ASSESSMENT REPORT

Finley Solar Project

Substation Upgrade Modification (SSD 8540 MOD 1)

Figure 1: Proposed project layout including Lot B DP 961693

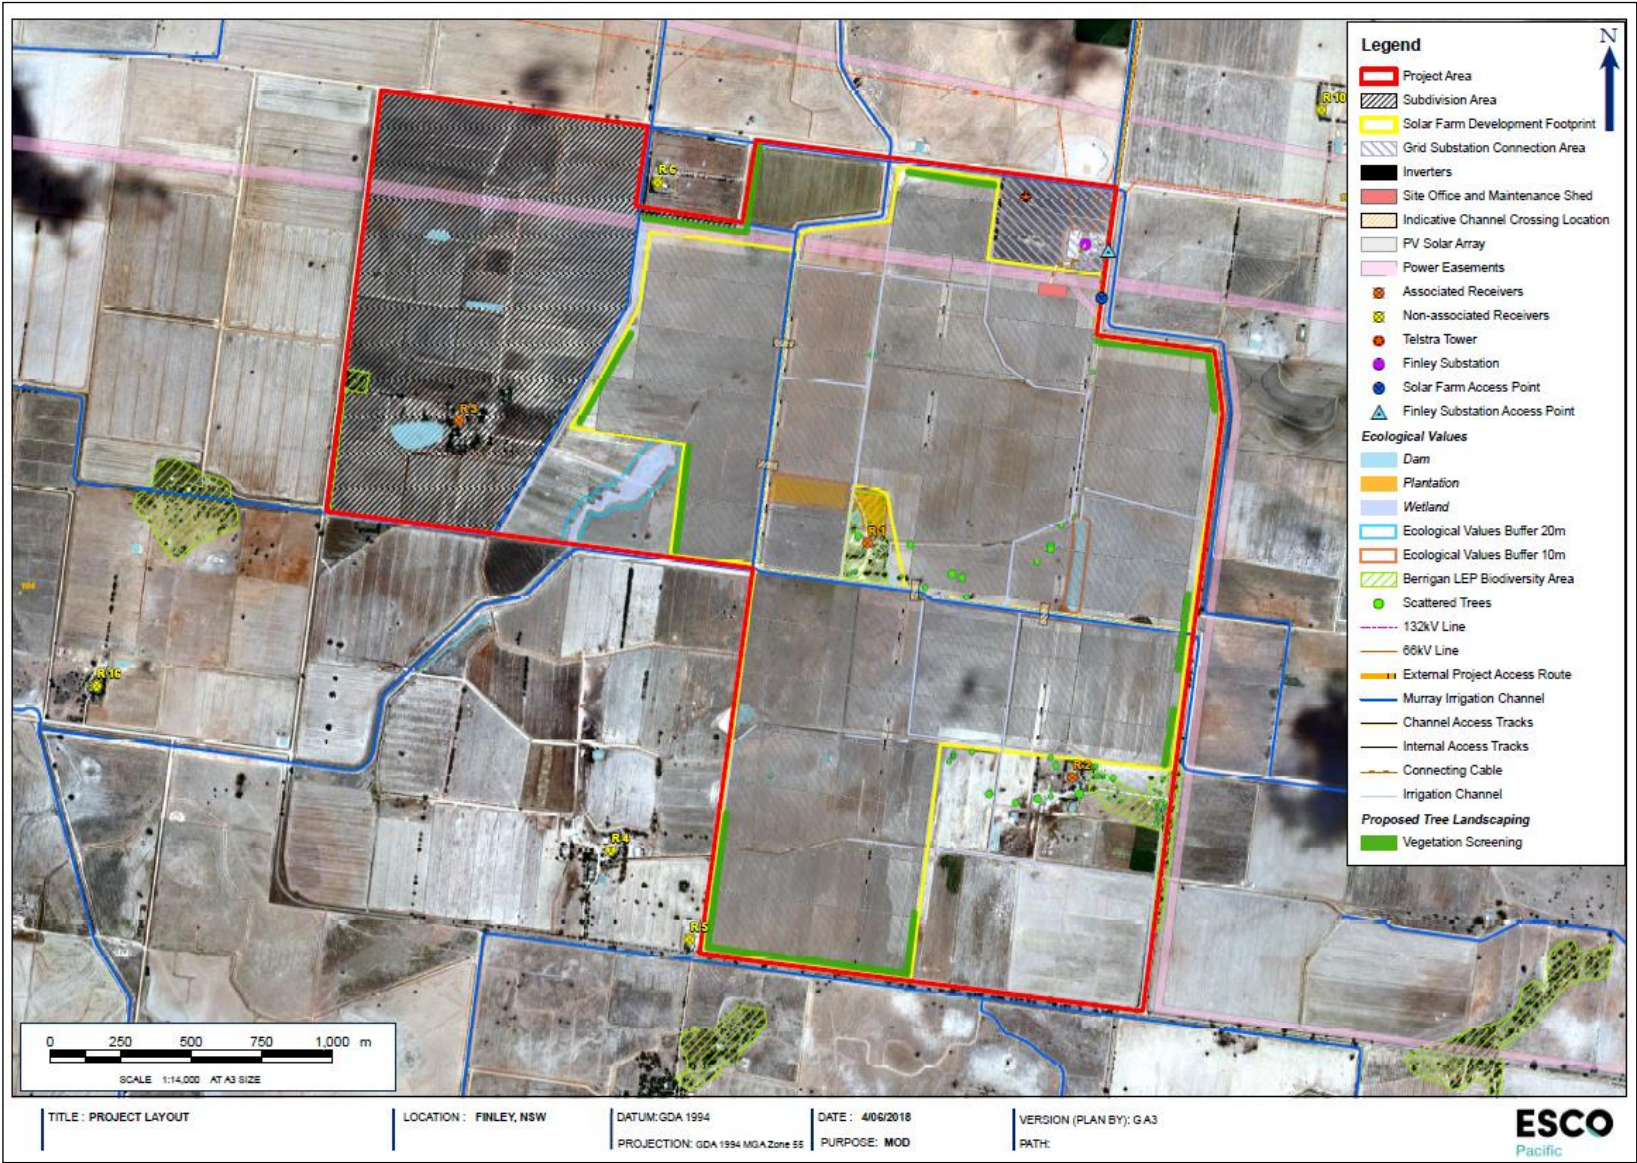
ESCO has advised the project can achieve a more efficient and economically viable connection to the grid by undertaking augmentation works to TransGrid's existing Finley substation (see **Figure 1**). ESCO has identified this as an alternative to connecting to the grid via the approved switchyard, located in the northeast of the project's development footprint.

To facilitate this change, ESCO is requesting to amend the layout and extend the project boundary to include the Finley substation and associated land parcel (Lot B DP 961693). In addition to amending the project layout, the schedule of lands for the project would need to be amended to include Lot B DP 961693.

The proposed augmentation works to the Finley substation would be largely completed within the existing substation footprint and would include a minor bench extension (up to 2,000 square meters) to accommodate specific transmission components such as switchgear, transformer and circuit breaker bay.
